FINAL PLAT

IRONHORSE AT OXFORD ADDITION
AN ADDITION TO WICHITA, SEDGWICK COUNTY, KANSAS

RE: SUB 2002-109 -- One-Step Final Plat of Ironhorse at Oxford Addition

CASE NUMBER: SUB 2002-109 -- IRONHORSE AT OXFORD ADDITION

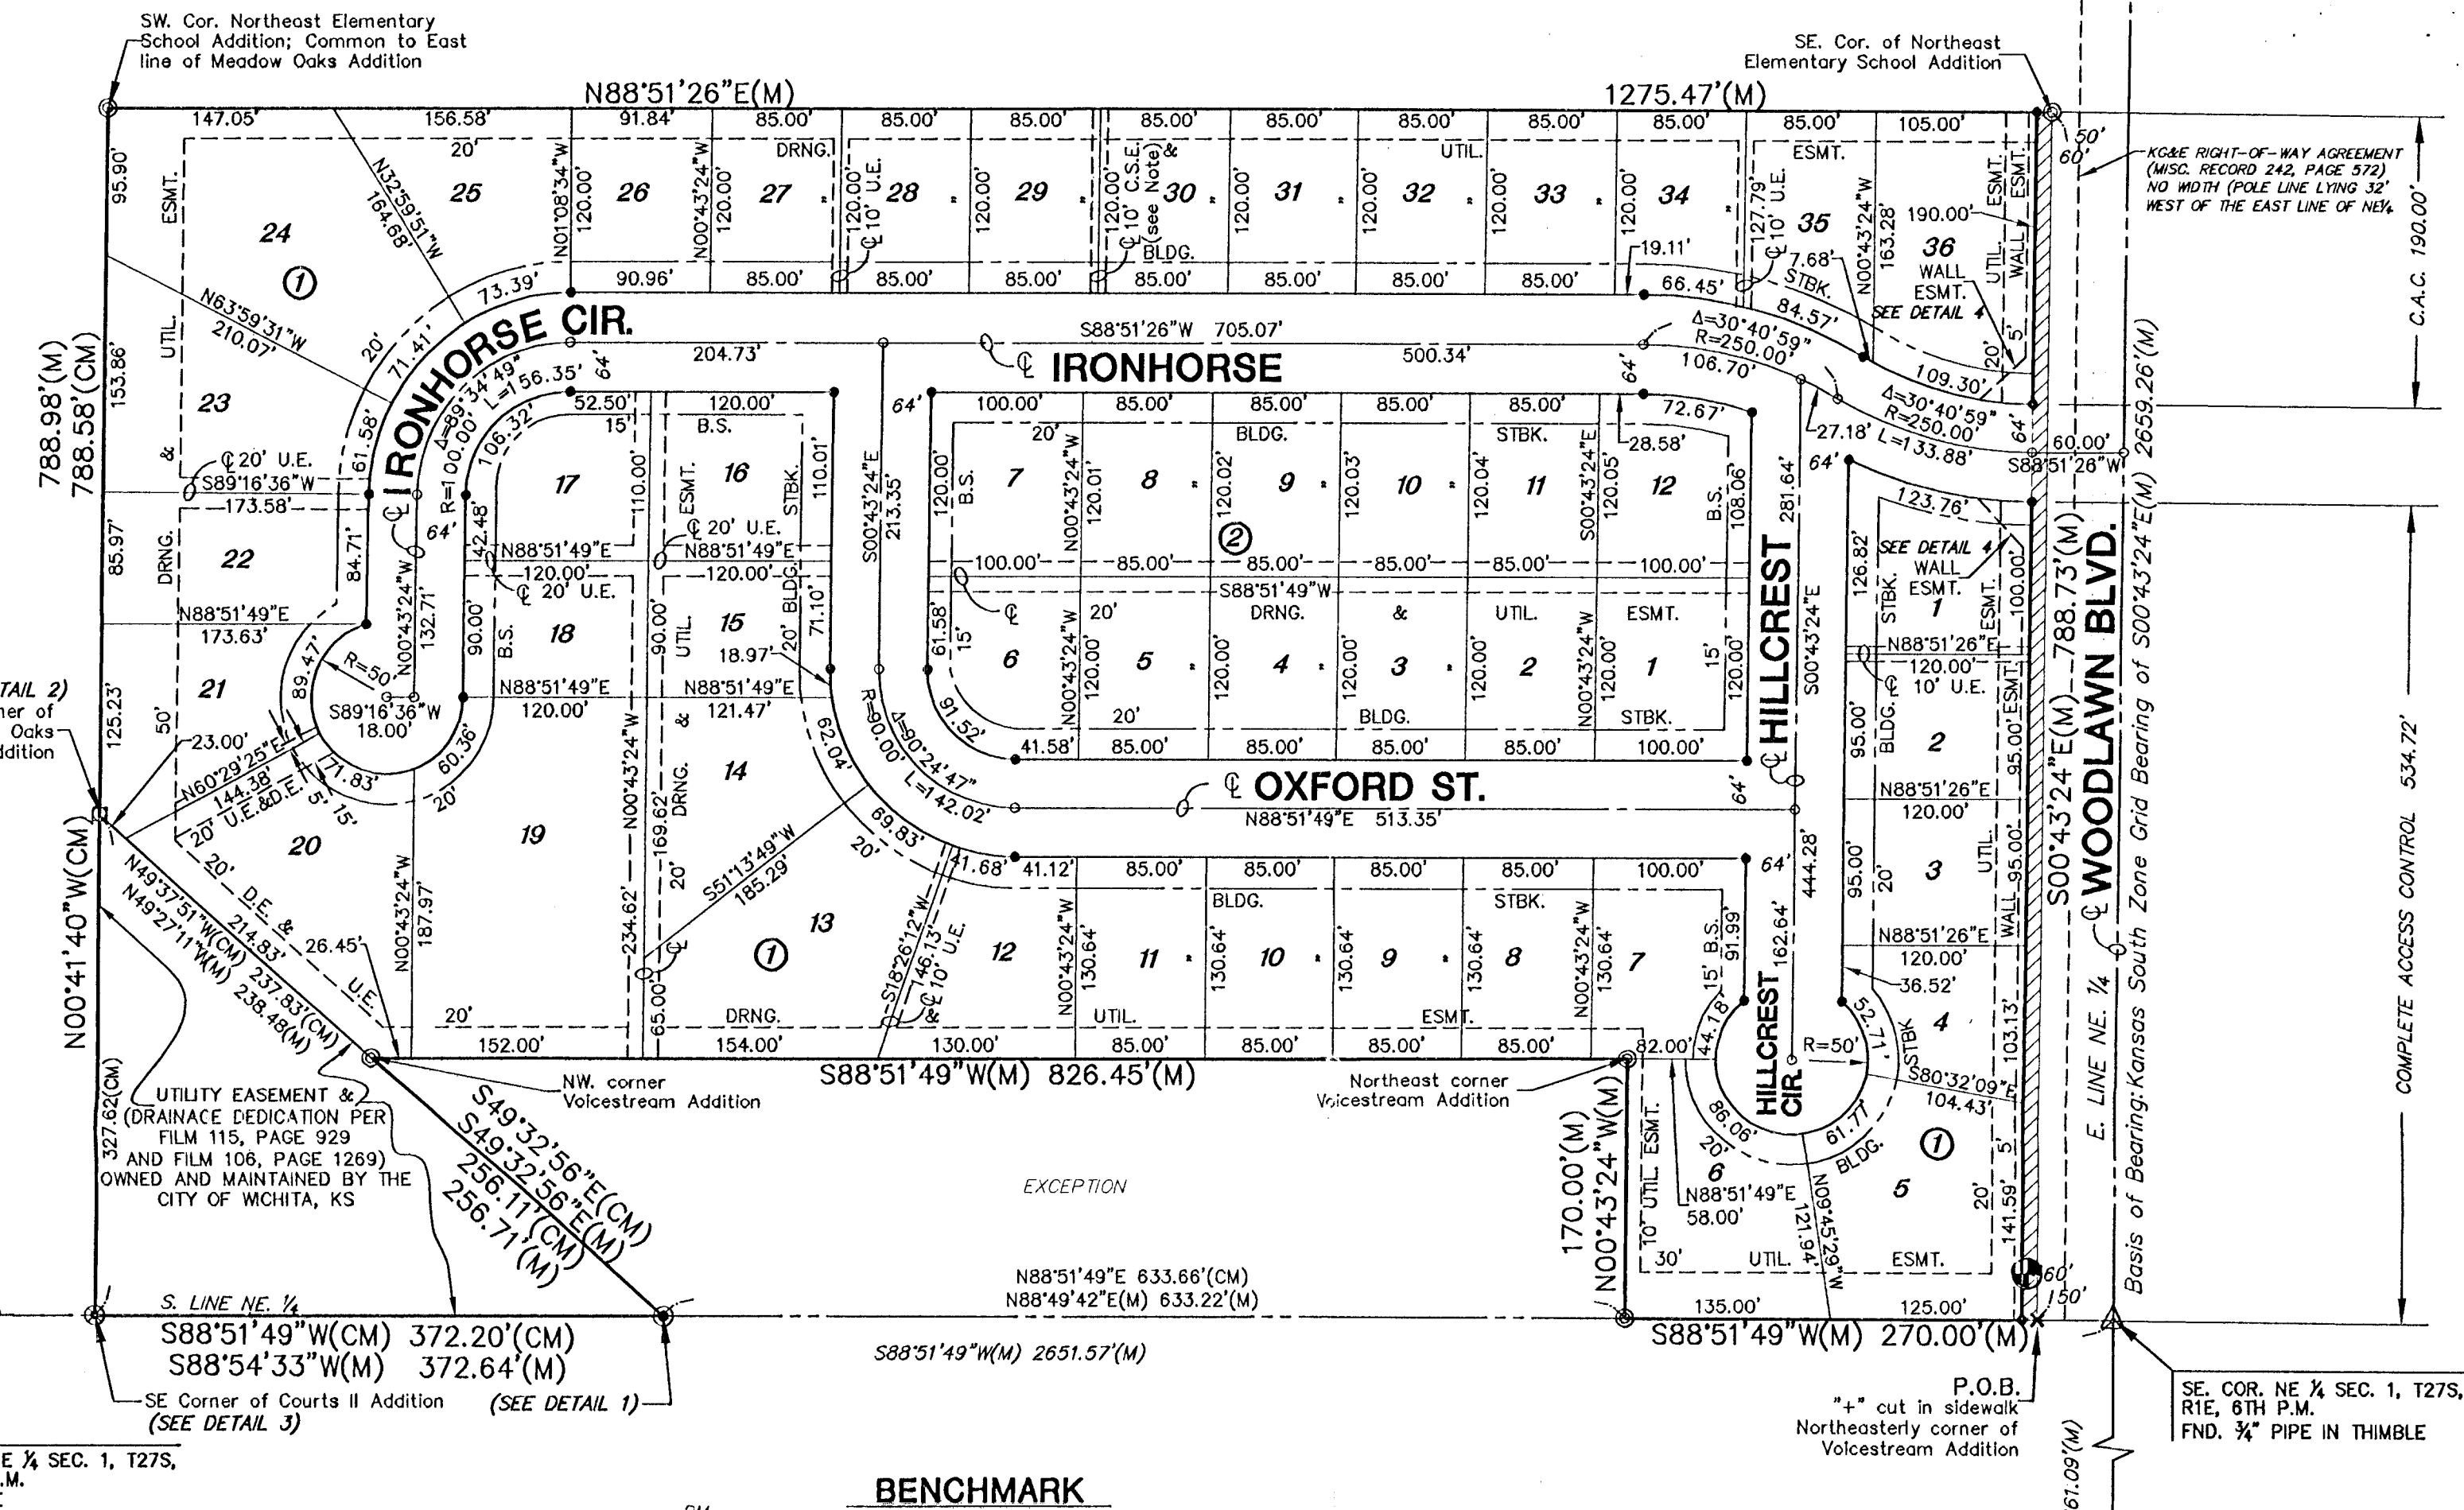
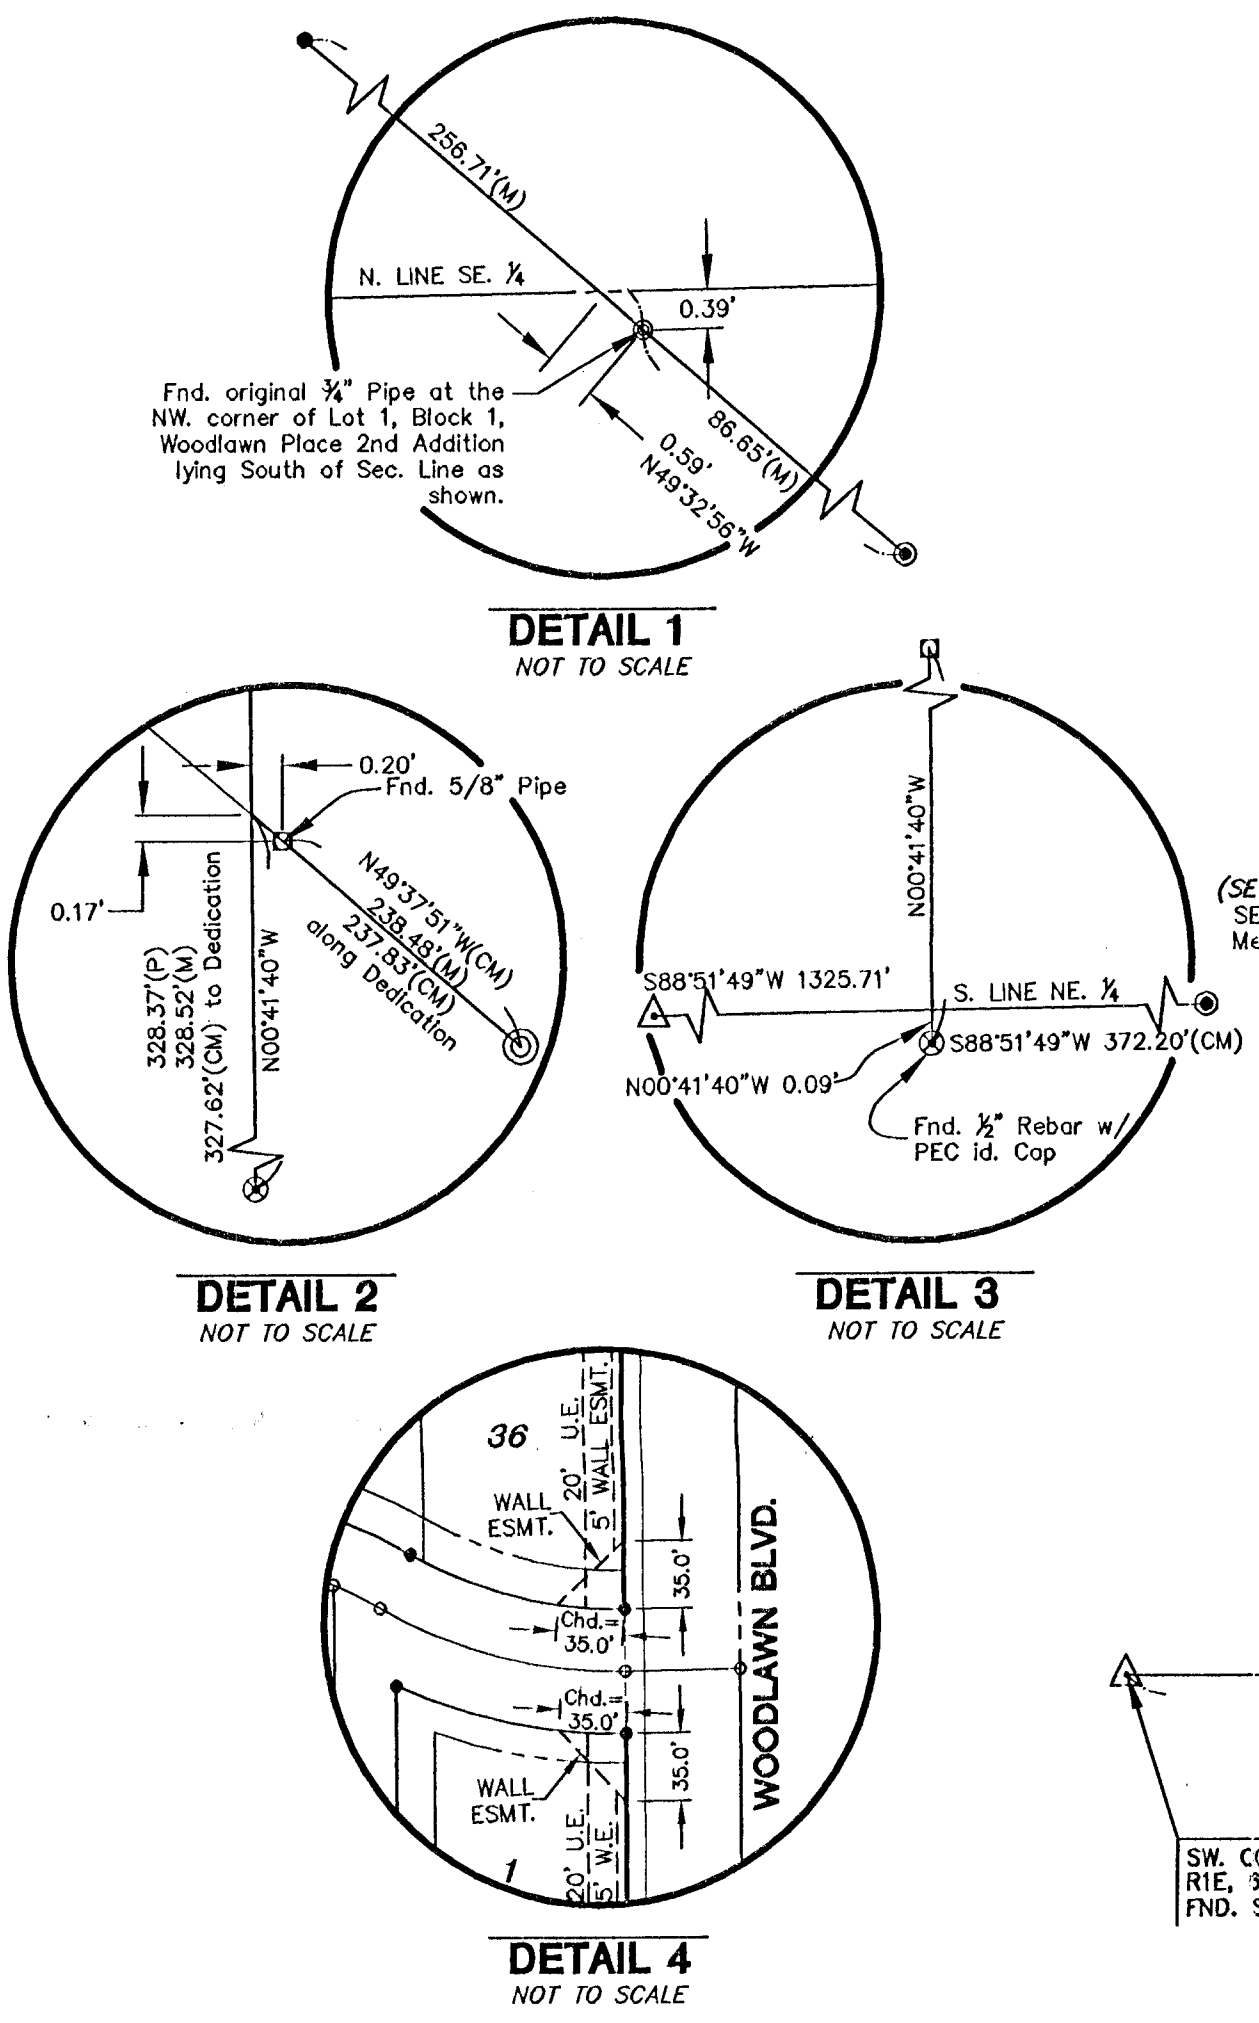
- E. The use of Reserve A for utilities located within platted easements should be referenced in the plat's text.
- F. Traffic Engineering has requested that the street opening for Ironhorse be relocated southward to be in alignment with the opening across Woodlawn.

- G. MAPD recommends a pedestrian access connection extending to the school property to the north. **The site plan for the school property shall be reviewed prior to the MAPC meeting to determine compatibility with a pedestrian connection through a platted reserve.**

- H. Traffic Engineering needs to comment on the need for any improvements to perimeter streets. **A guarantee for a left turn lane is needed.**

- I. **Traffic Engineering** has requested the dedication of additional right-of-way along Woodlawn to conform with the 60-ft half-street right-of-way required by the Access Management Policy.

- L. The wall easement shall be referenced in the plat's text.
- M. The Applicant has platted 20-ft building setbacks which represents an adjustment of the Zoning Code standard of 25 feet for the TF-3, Two-Family District. The Subdivision Regulations permit the setback provisions to be modified by the plat upon the approval of the Planning Commission.

- N. The **City Fire Department/GIS** needs to comment on the plat's street names. *The street names are approved.*
- O. The sewer easements (Film 145, Page 104) and (Film 45, Page 116) need to be located.

- P. The centerline of Ironhorse needs to be located along Woodlawn.
- Q. The Applicant is reminded that a platting binder is required with the final plat. Approval of this plat will be subject to submittal of this binder and any relevant conditions found by such a review.

- R. The plat's text shall include language that a drainage plan has been developed for the plat and that all drainage easements, rights-of-way, or reserves shall remain at established grades or as modified with the approval of the applicable City or County Engineer, and unobstructed to allow for the conveyance of stormwater.

- Z. The representatives from the utility companies should be prepared to comment on the need for any additional utility easements to be platted on this property. Westar Energy and Southwestern Bell have requested additional easements.

At the regular meeting of the Metropolitan Area Planning Commission on November 7, 2002, the above captioned plat was considered. The action of the Planning Commission was to approve the plat as recommended by the Subdivision Committee, subject to the conditions stated in our letter dated November 1, 2002, including a revised Item "G" as follows:

A contingent sidewalk easement shall be platted extending to the school property to the north. The easement shall become effective upon extension of the sidewalk northward through the school property. Expiration of this contingent sidewalk shall occur two (2) years after the recording date of this plat.
